South Texas Project Electric Generating Station 4000 Avenue F – Suite A Bay City, Texas 77414

July 2, 2008  
ABR-AE-08000048

South Texas Project  
Units 3 and 4  
Docket Nos. 52-012 and 52-013  
Response to Requests for Additional Information

Reference: Letter, Paul Kallan to Greg Gibson, "Request for Additional Information, Letter Number One Related to the Environmental Report for the South Texas Combined License Application", dated May 19, 2008 (AE-ABR-08000097)

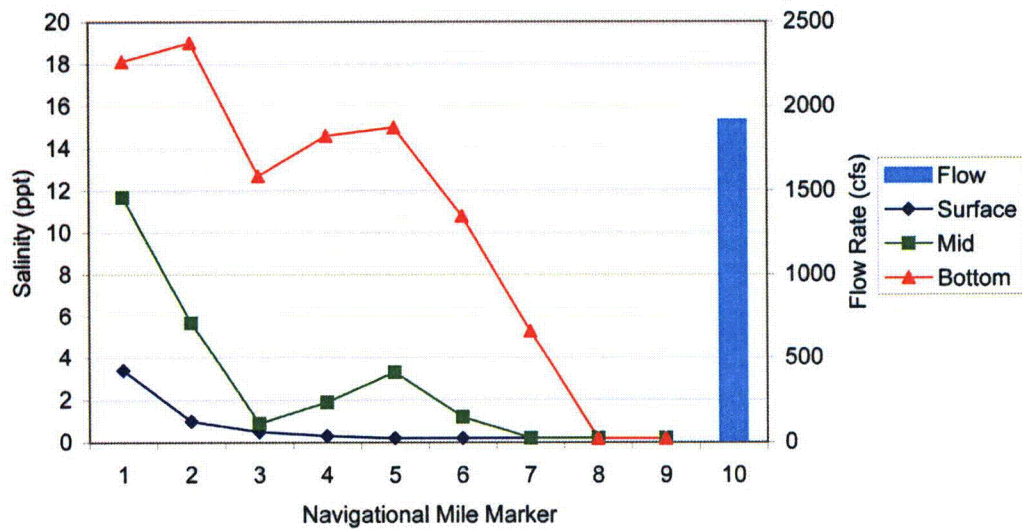
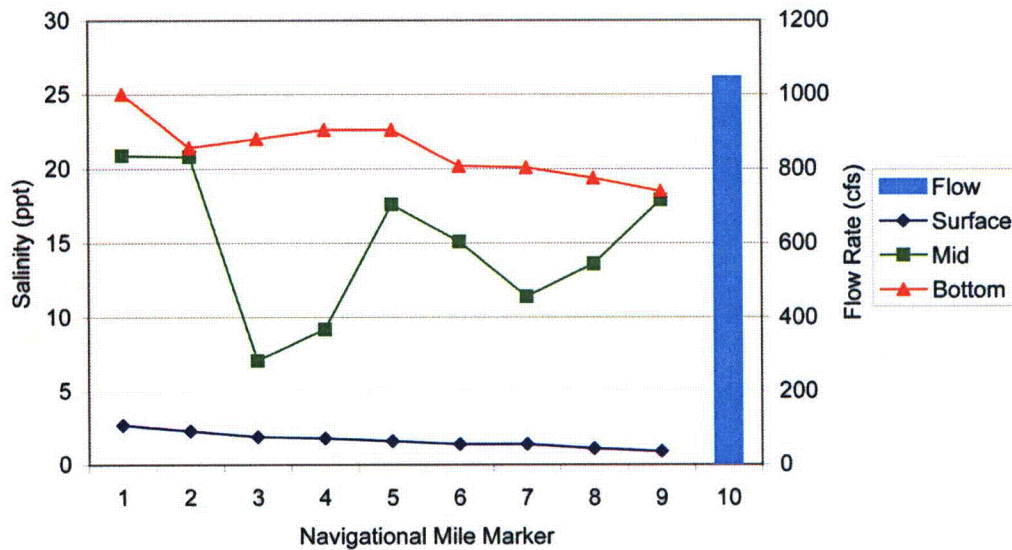
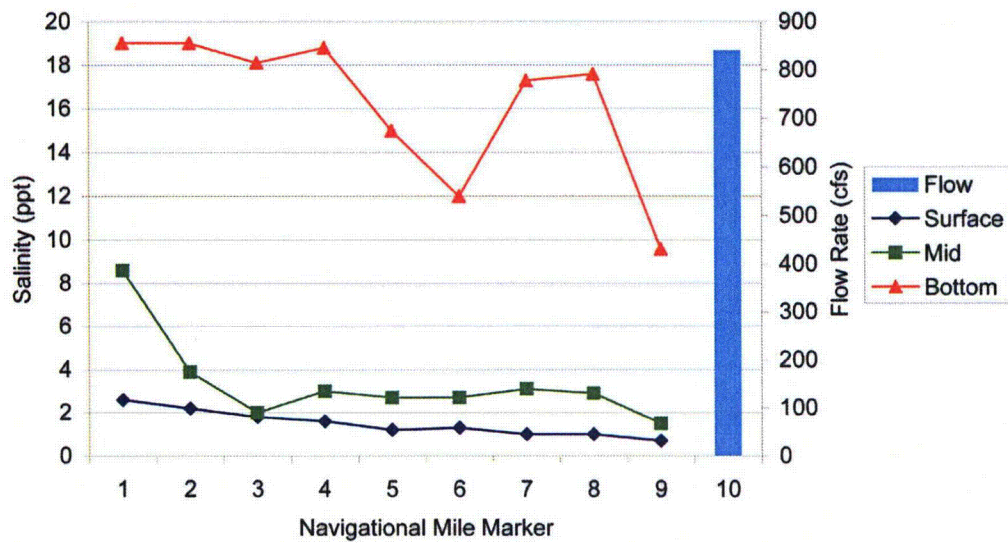
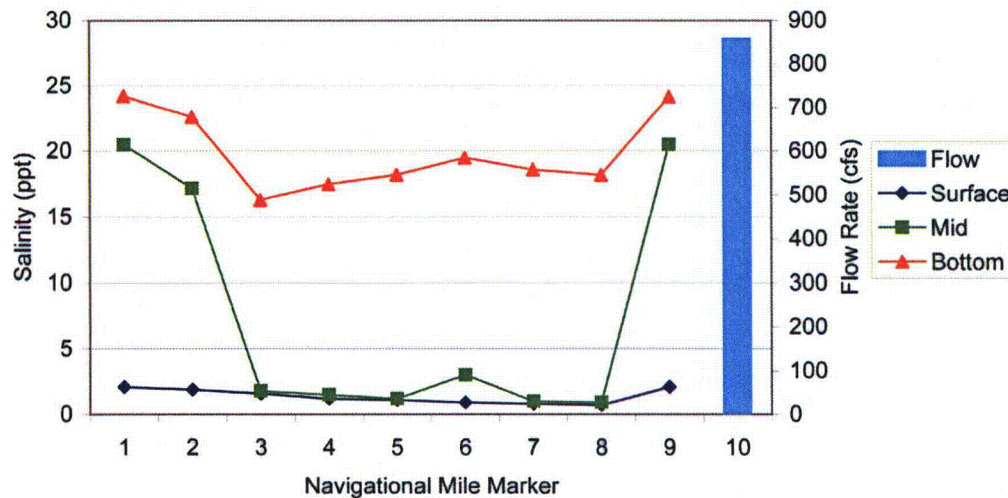
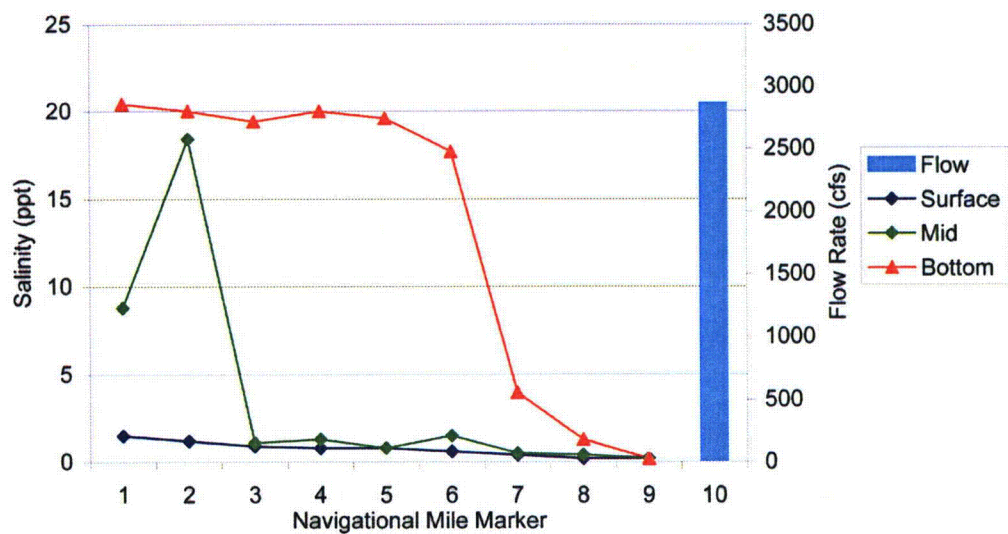
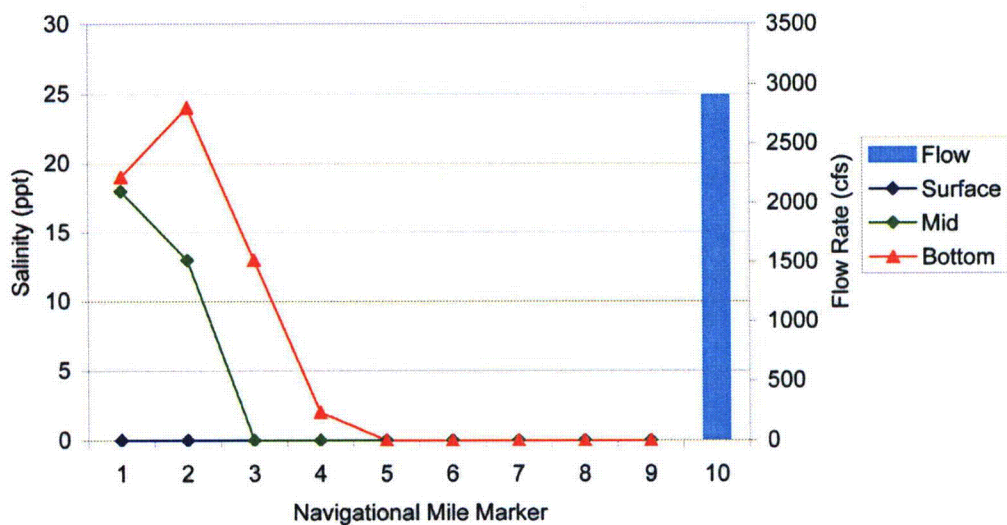
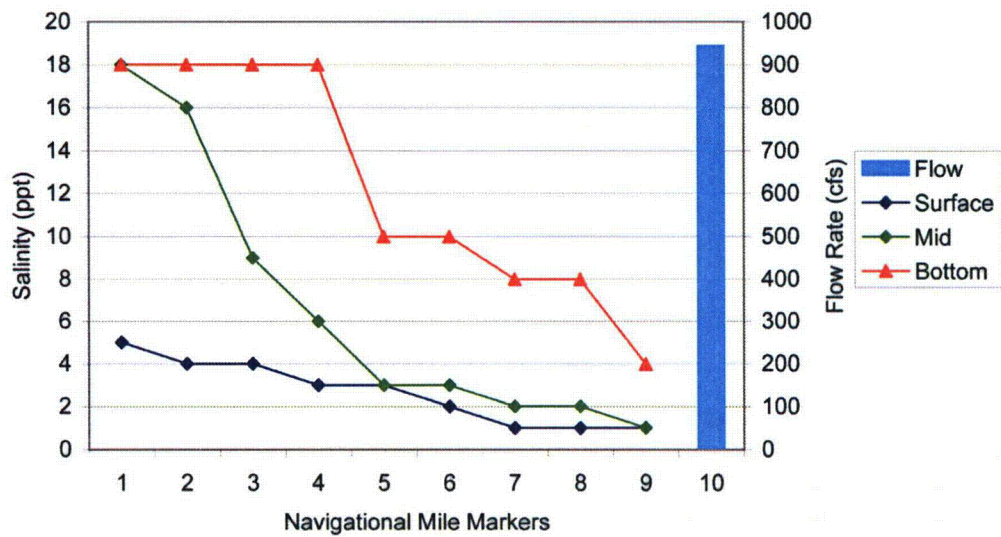
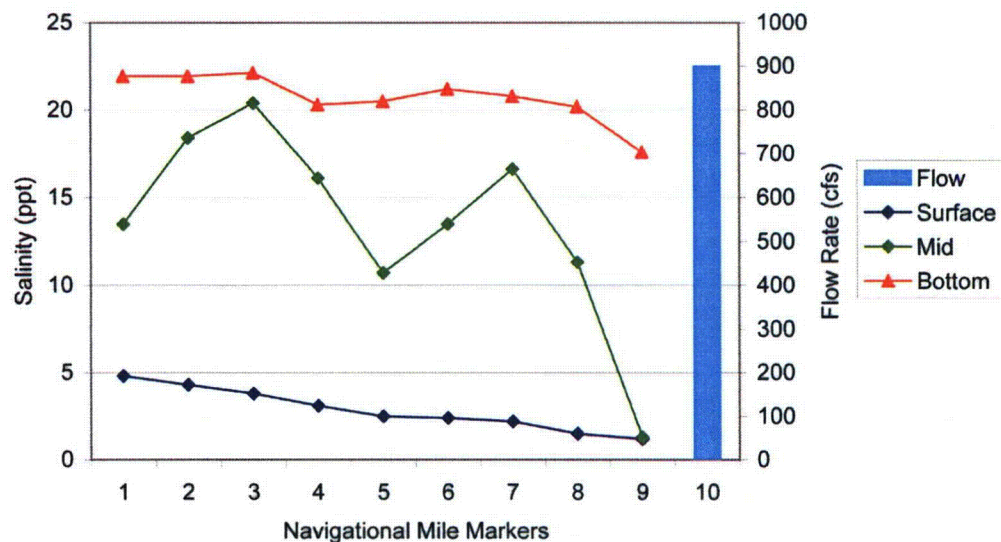
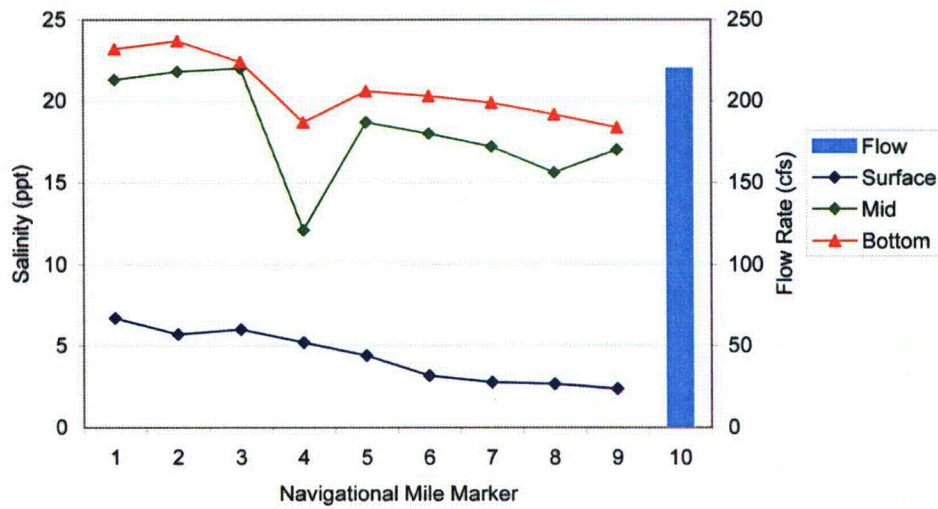
Provide the location and other pertinent data for the salinity wedge in the Colorado River during various discharges.

Provide pertinent data and information on the location of the salinity interface opposite the intakes in the Colorado River, and its position during different river flow conditions.

**RESPONSE:**
